PERMIT

SEWAGE DISPOSAL SYSTEM

HOWARD COUNTY
BUREAU OF ENVIRONMENTAL HEALTH
992-2330

REPAIR - Moving 2000 gallon septic tank to new area to make room for an addition
off existing building.

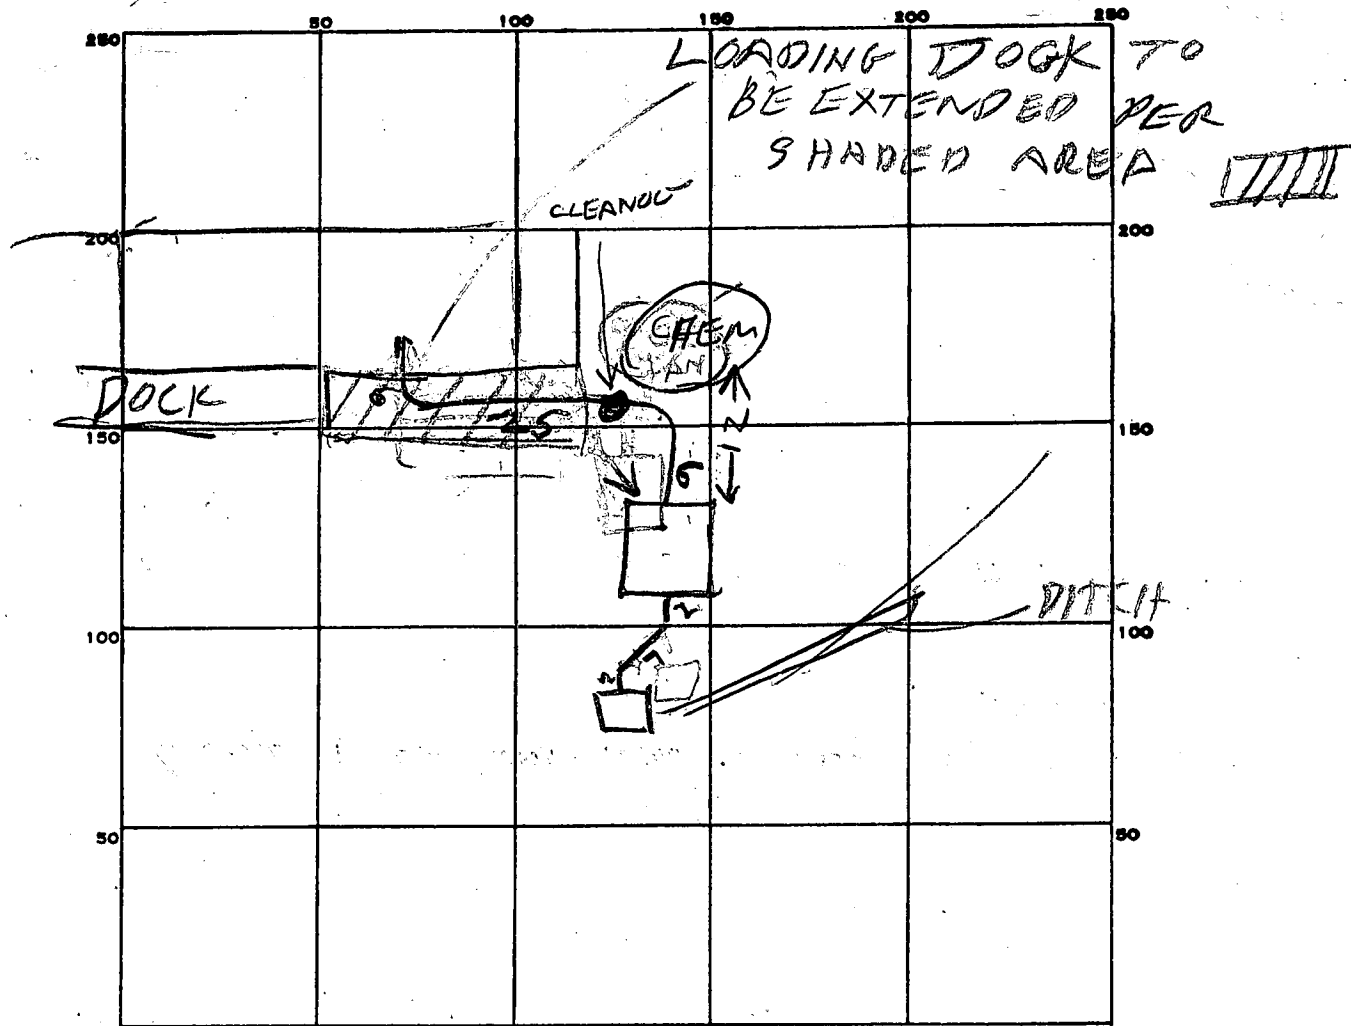
REMARKS 5/2/84 LOADING DOCK TO BE EXTENDED
SO TANK WAS MOVED. TANK TO BE 13 FT
FROM NEW LOADING DOCK. SKIP SAID DITCH
SYSTEM NOT NEAR LOADING DOCK EXTENSION
CONNECT TANK TO DISTRIBUTION BOX & INSTALL CLEANOUTS
5/2/84 TANK CONNECTED
